From: Richard Du Bey <RDuBey@scblaw.com>
Sent: Thursday, April 20, 2017 6:02 PM
To: Olson, Erik
Cc: KHanson@ldftribe.com
Subject: FW: Groundwater modeling Data

Thanks for reaching out to discuss the reason why Tribal professional staff are reluctant to share certain modeling data, regarding the Haslell lake LUST site, that was generated by EPA's contractor. As you and I discussed on April 14, quality controlled, properly handled, and analyzed groundwater and soil sampling data should not be subject to claims of confidentiality, but should be openly disclosed and used to determine the nature and extent of contamination. However, that is not the issue that we are currently dealing with at the Haskell lake Site. It is not a question of whether quality data should be released, it is a question of whether a potentially inaccurate and non-representative computer generated model should be used as the basis for remedial decision-making.

From: Hanson, Kristen [mailto:KHanson@ldftribe.com]
Sent: Tuesday, April 18, 2017 9:55 AM
To: Richard Du Bey <RDuBey@scblaw.com>
Cc: Allen, Dee <dee.allen@ldftribe.com>; Wawronowicz, Larry <lwawronowicz@ldftribe.com>
Subject: RE: Groundwater modeling Data

Model 1

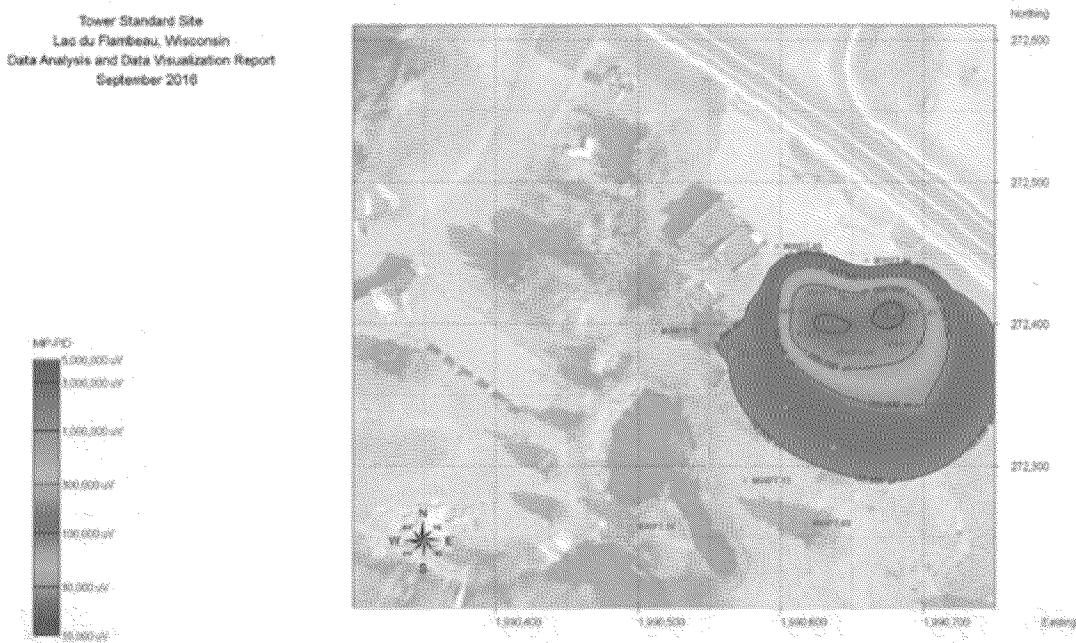
The plume shown in model 1 is based on the incomplete data set and extends further to the east than existing data suggests, does not account known site data, and does not show the plume path from the source area to the lake including the MW16 well nest.

Figure 5: MIP-PID Response 2D Maximum

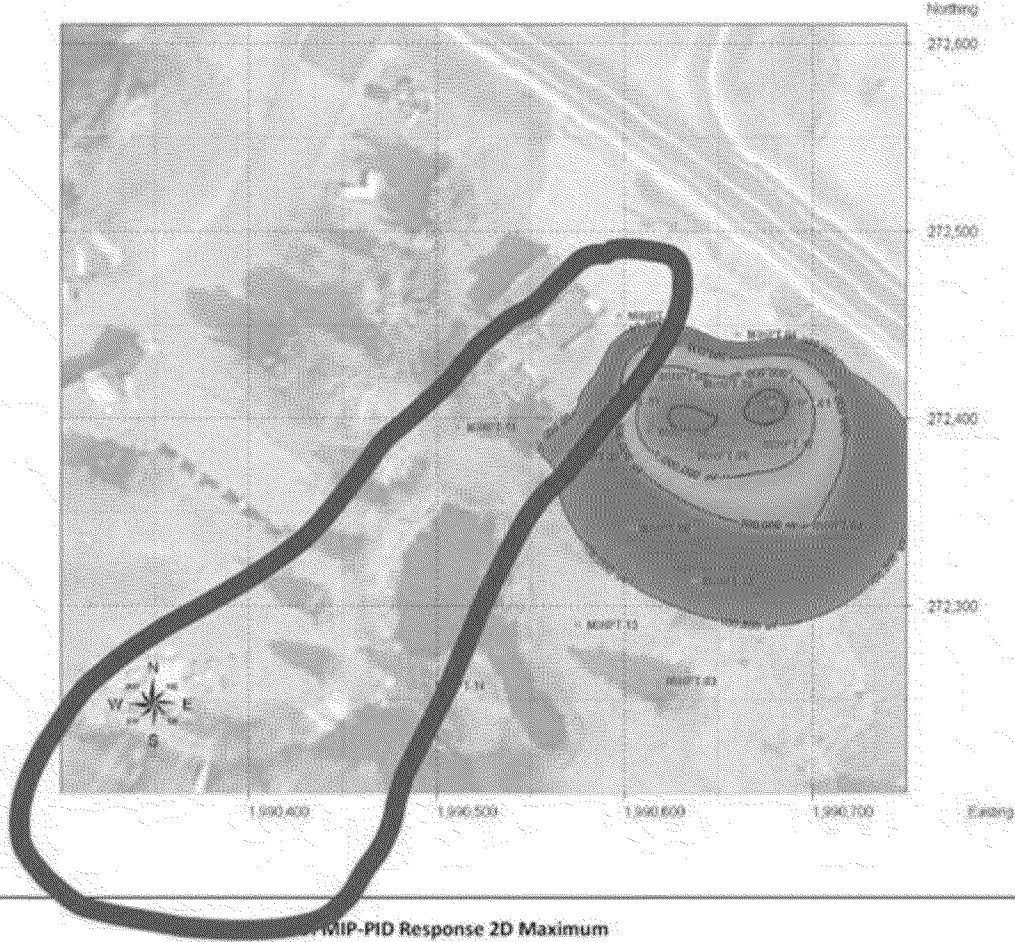
The Area in red is known substantial contaminated groundwater plume, and is not included or represented in the graphic representation.

It was our understanding that the model was being updated to include all data (including the known plume area) and would not be ready until the week after Thanksgiving.

Model 2

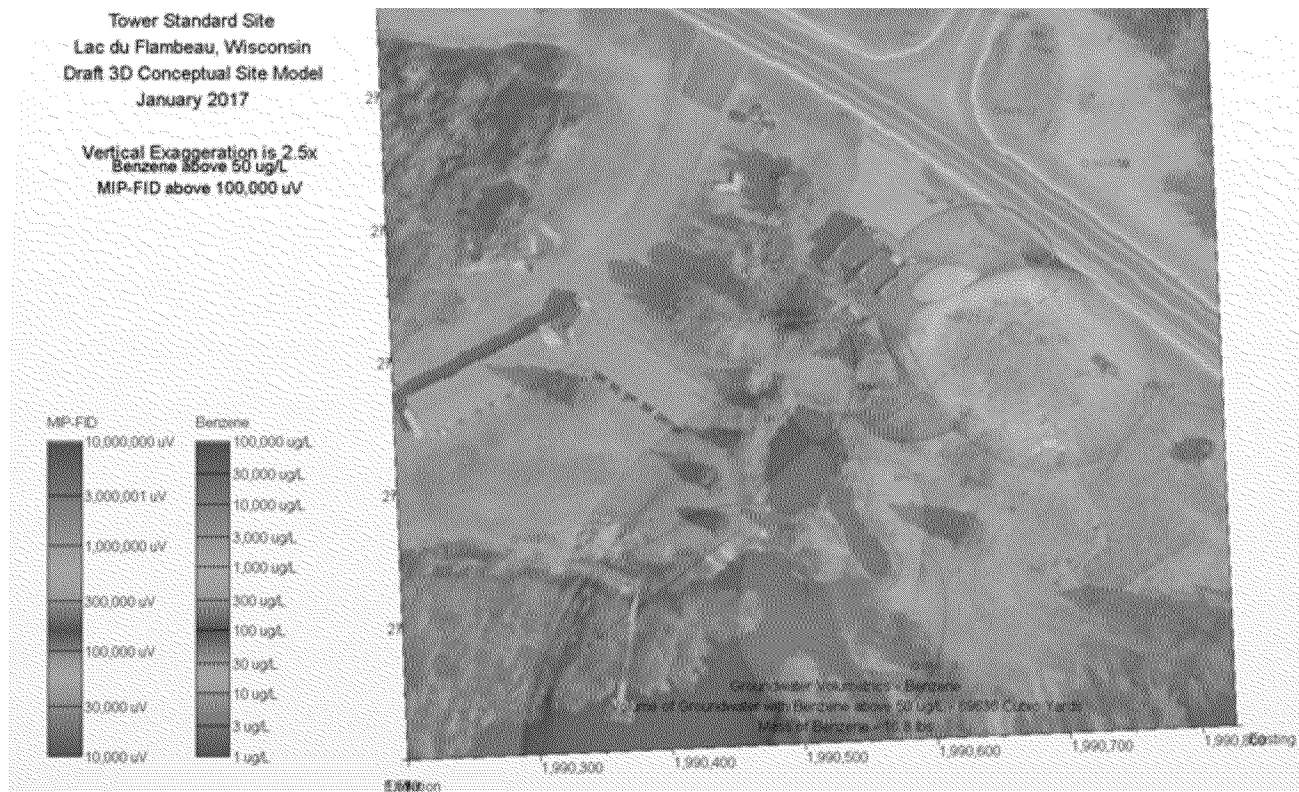
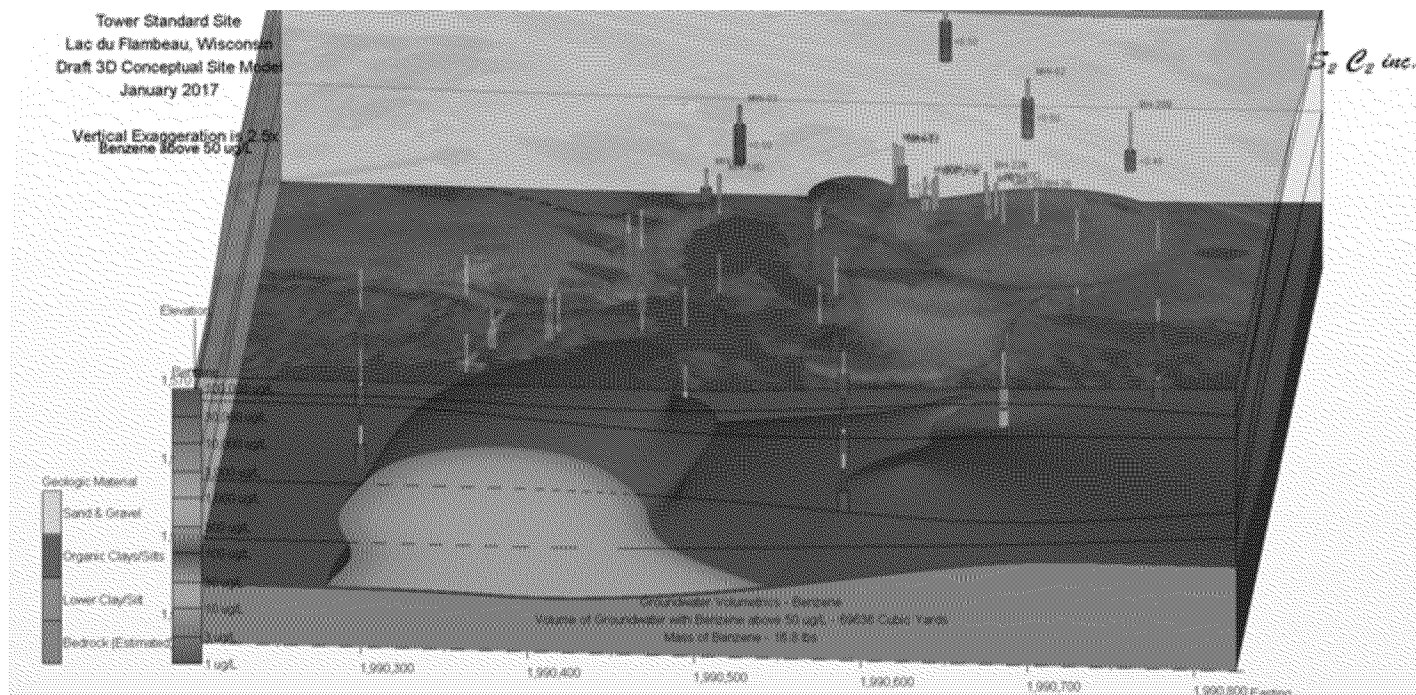
This model shows two separate plume, one near the road, and a separate plume near the lake rising from the bedrock. In many places, the model does not represent actual site data and extends the plume to the east in areas of known clean areas.

Tribal Comments include model extends further to the east than data supports

Model 2 shows 2 separate plumes, one near the road and one rising from the bedrock near the lake. This interpretation is not likely and different than what reasonable data interpretation suggests.
